SIMON GENERAL COMMENTS:

SIMON FLOOR PLAN COMMENTS:

EssilorLuxottica Project Number 101228

3 STOREFRONT ELEVATION
 SCALE: 1/2" = 1'-0"

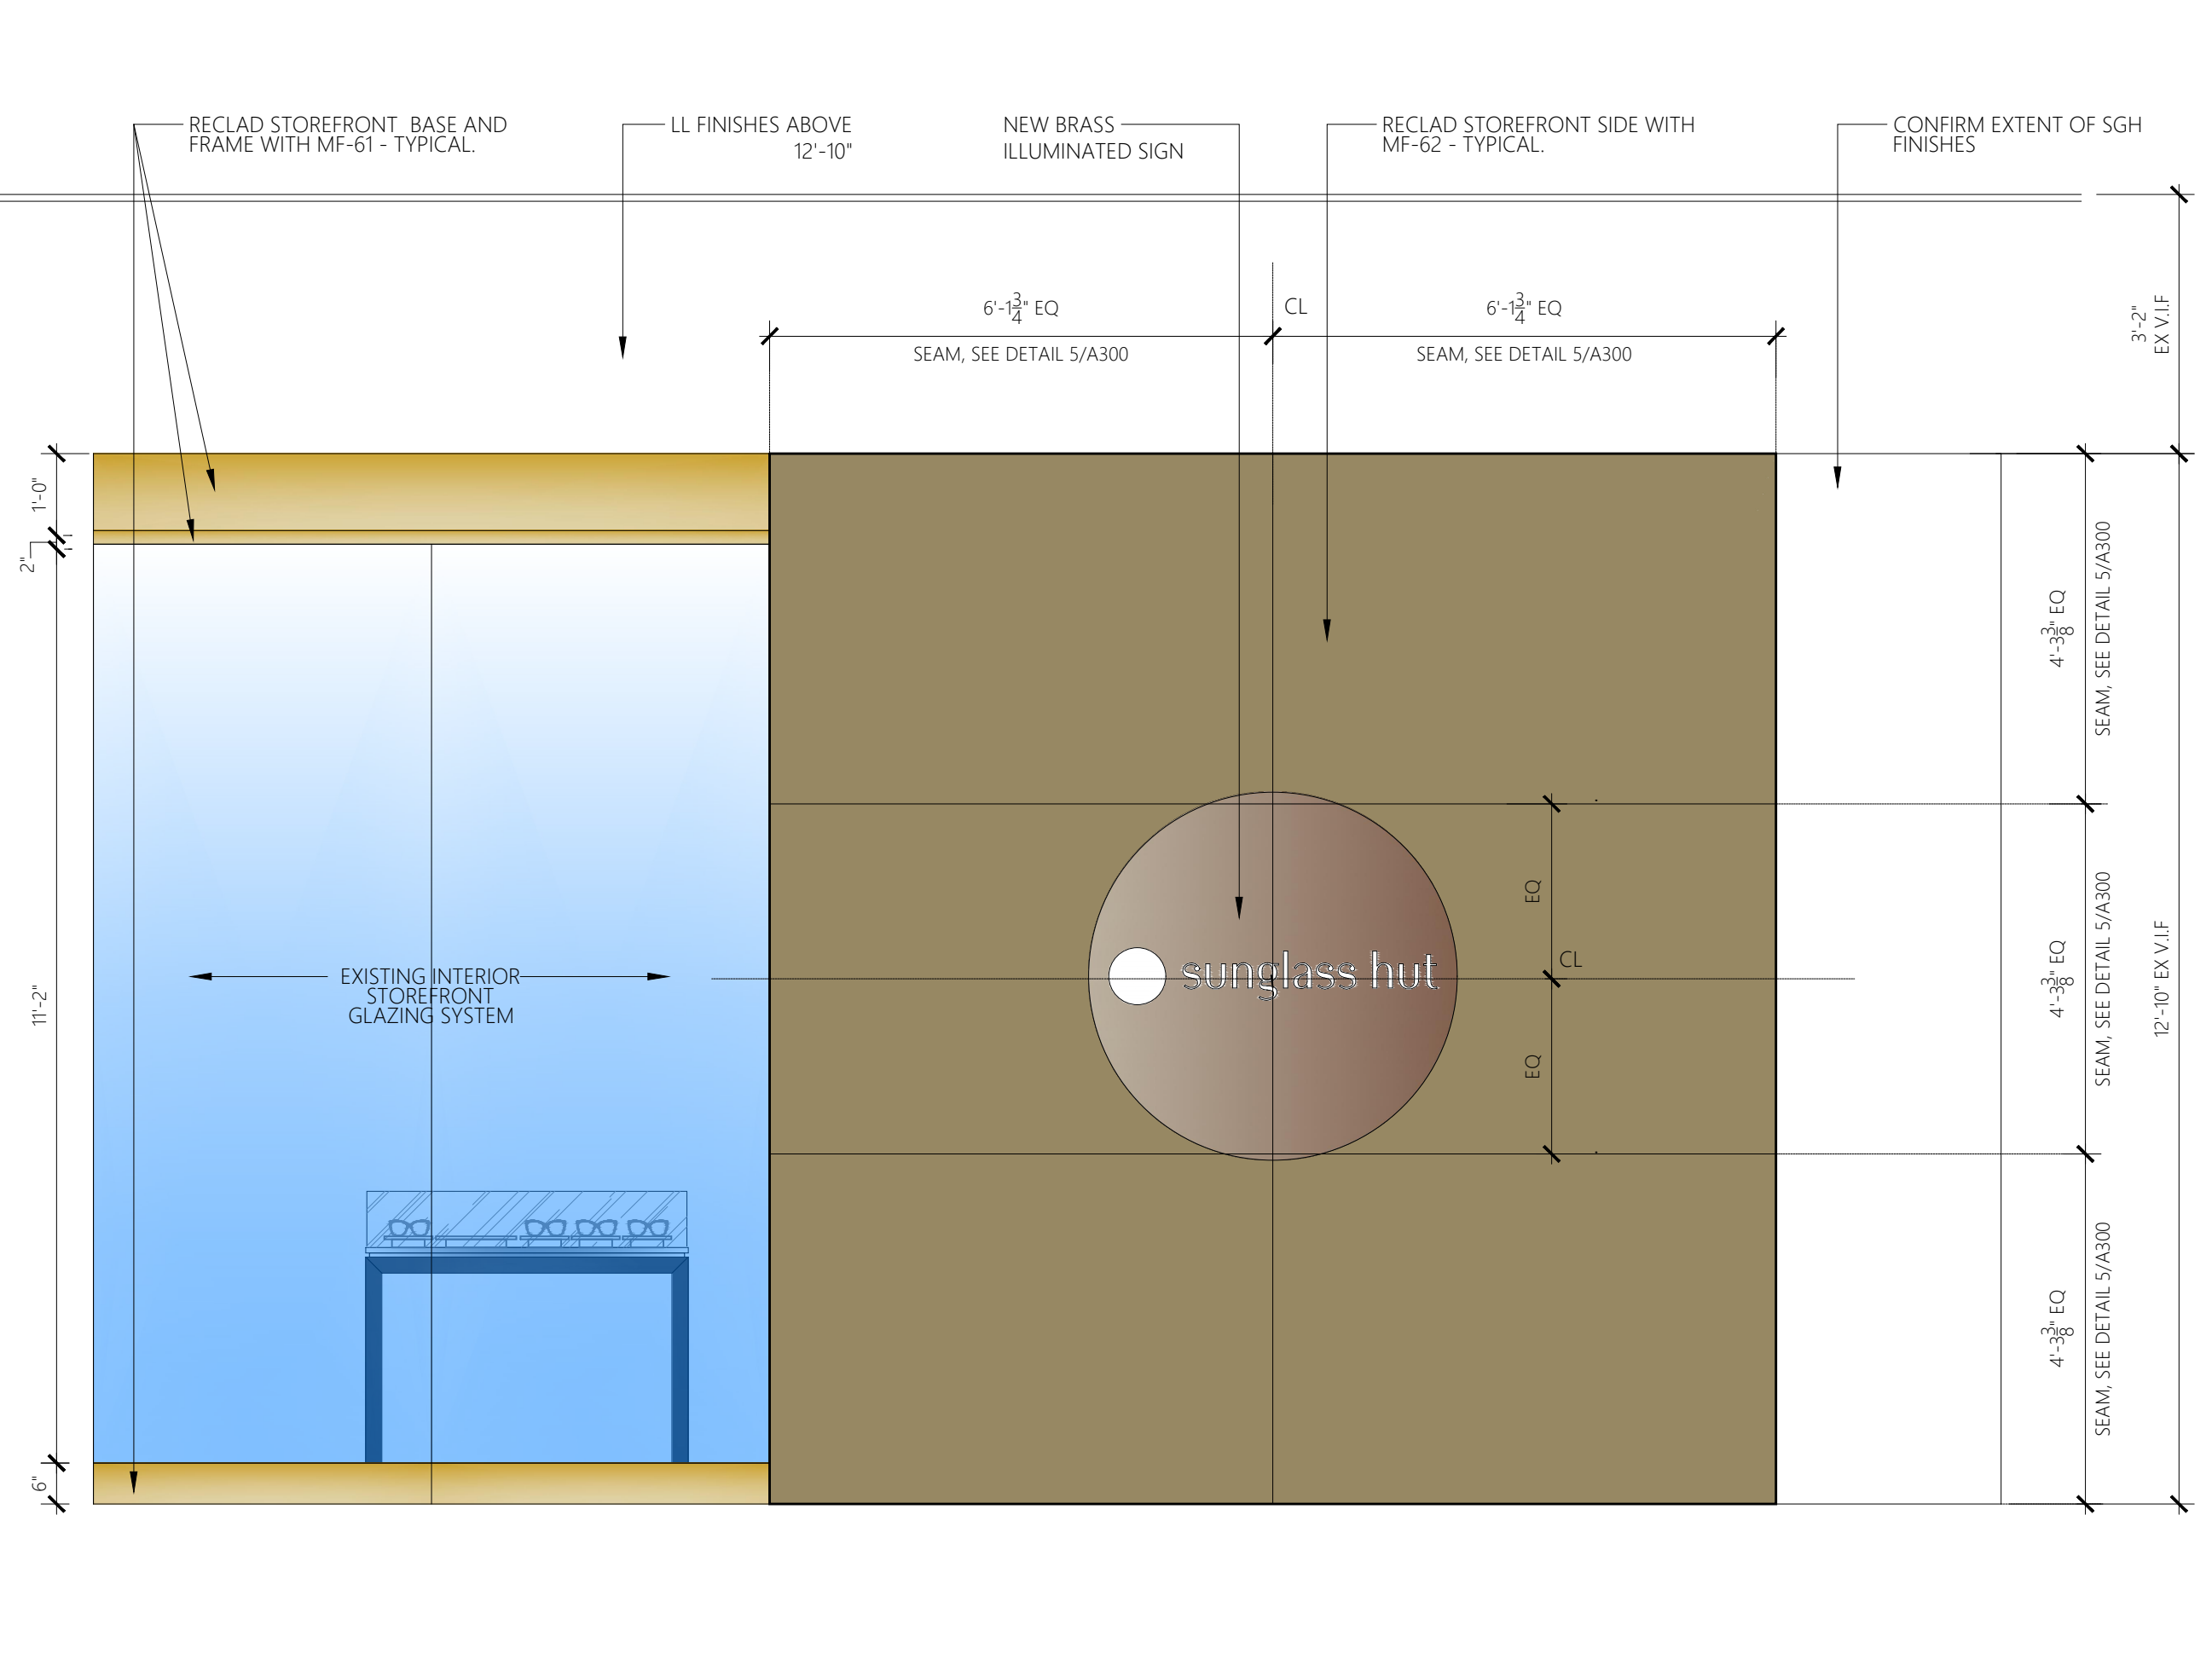
LL COMMENT (N/D): STOREFRONT SIGNAGE:
 TENANT TO INSTALL NEW STOREFRONT SIGNAGE TO MEET SIGN CRITERIA.
 TENANT RESPONSIBLE FOR PATCHING / REPAIRING / REFINISHING EXTERIOR FAÇADE FROM PREVIOUS TENANT SIGNAGE REMOVAL. PRIOR TO NEW SIGNAGE INSTALLATION, THE OPERATIONS DIRECTOR MUST APPROVE SAID REPAIRS.
 STOREFRONT SIGNAGE, STOREFRONT ENTRY LIGHTS, SHOW WINDOW LIGHTS AND SHOW WINDOW RECEPTACLES TO BE ON 24-HOUR / 7-DAYS A WEEK TIME CLOCK.
 NOTE: GC TO PROVIDE ADEQUATE BLOCKING AT SIGN LOCATIONS.
